INDESIT company

Model type:
UP1712FHA

Commercial code:
F052359

n3008a04: ES VARIANTS-PCB, PROG, C/PANEL, DAMPER & M/FLOW

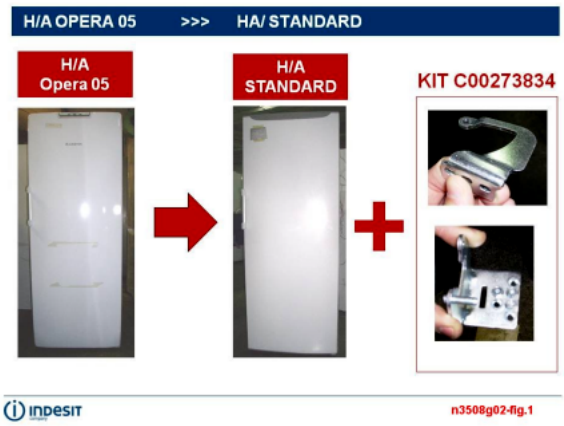
A new design of Power board was introduced to existing single door above counter fridges and freezers in week 44 (29/10/07) Serial No. commencing 71029. Similarly, to combo's in week 1 2008 (02/01/2008).
The new board is mounted at the top behind the facia control panel rather than rear mounted, as previously.
It is supplied UNPROGRAMMED, and does NOT have a replaceable EEPROM. It also requires requires special equipment to programme it.
The control panel has also been updated to accept the the new larger power board, as have the multiflow and damper arrangement.

Apart from visually inspecting the appliance; the only way to know which power board is fitted, refer to the rating plate for the serial number. i.e. Before and after serial numbers 71029 & 80102.

n3508a02: INTRO ES MODELS - NEW PCB, PROG & C/PANEL

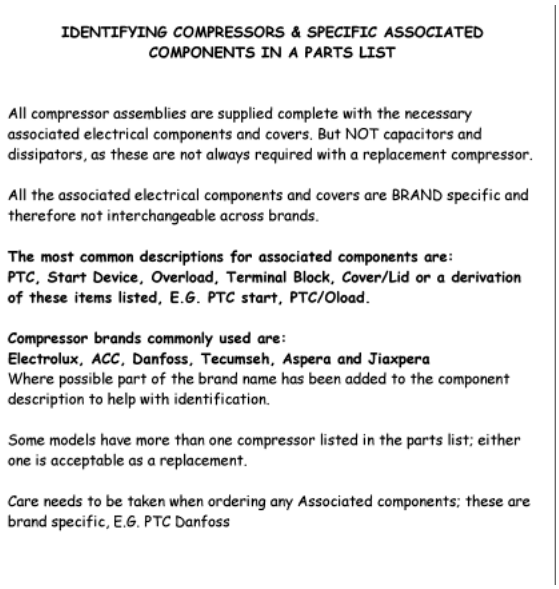
A new design of Power board was introduced to existing models in week 44 (29/10/07) Serial No. commencing 71029. The new board is mounted at the top behind the facia control panel rather than rear mounted, as previously.
It is supplied UNPROGRAMMED, it also, does not have a replaceable EEPROM and requires special equipment to programme it.
The control panel has also been updated to locate the the new larger power board.

Apart from visually inspecting the appliance; the only way to know which power board is fitted, refer to the rating plate for the serial number. i.e. Before and after serial number 71029.

POWER MODULE ROHS NON-PROGRAMMED & SMARTCARD

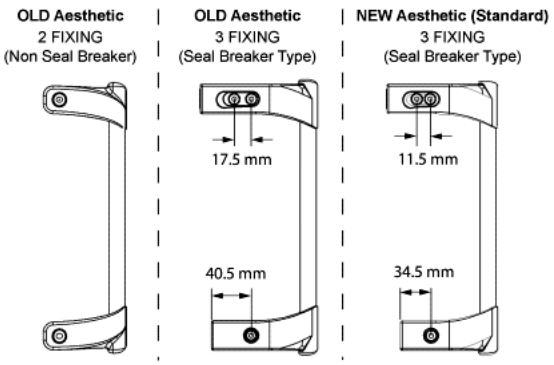
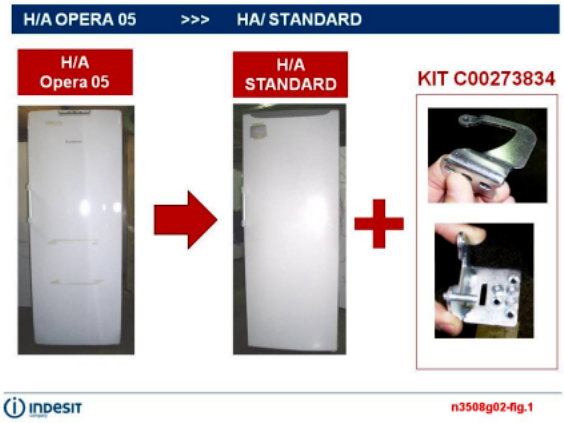
A new design of Power module was introduced to existing models commencing Serial No. commencing 71029.... The new module is mounted at the top behind the facia control panel rather than rear mounted, as previously. The power module is supplied **UNPROGRAMMED,** requiring a Smartcard and special equipment to programme it.

To identify which power module is fitted, refer to the rating plate for the serial number. i.e. before and from serial number 71029.... NOTE: The control panel mounted power module was introduced to a small number of models prior to serial number 71029.... Therefore in some instances a visual inspection for the location of the module will be necessary to identify the type fitted.

NOTE: The programmed Eeprom from the parts list can **ONLY** be used on the Rear Mounted Power Module. When the programmed Eeprom is not longer available, It will be necessary to programme the power module using the relevant Smartcard and special equipment listed. It will also be **NO** longer necessary to insert a separate Eeprom whenever an Eeprom socket is encountered on an existing module when using the Smartcard.

CONTROL PANEL MOUNTED POWER MODULE - ES

SPECIAL EQUIPMENT REQUIRED
A = Smartcard (can only be used **ONCE**).
B = Smartcard Reader (is **RE-USABLE**).
C = Low End Adaptor Version 2007 (is **RE-USABLE**).

In order to locate the correct programme file on your Palm/PC-EMIT it will be necessary to search under the part number of the Smartcard associated with the relevant power module in the parts list. The Low End Adaptor **version 2007** will also be required to programme the Control Panel Mounted Power Module - ES.
